CPF Hydraulics
Pump to MV Weldment Modification

Gene Massion
Monterey Bay Aquarium Research Institute
831 7751922
magene@mbari.org

2016 May 19

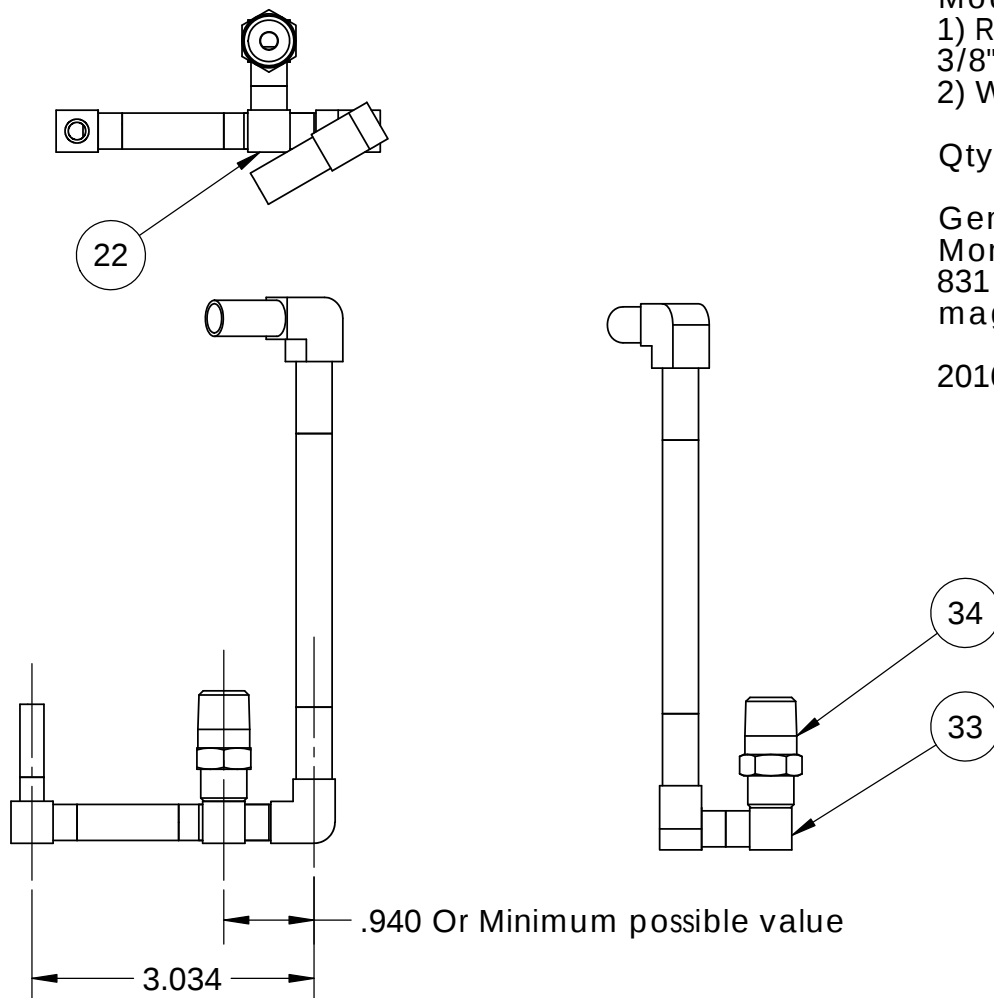
Modification consists of:

- 1) Remove section from lower horizontal 3/8" tube
- 2) Weld in items 22, 33 and 34
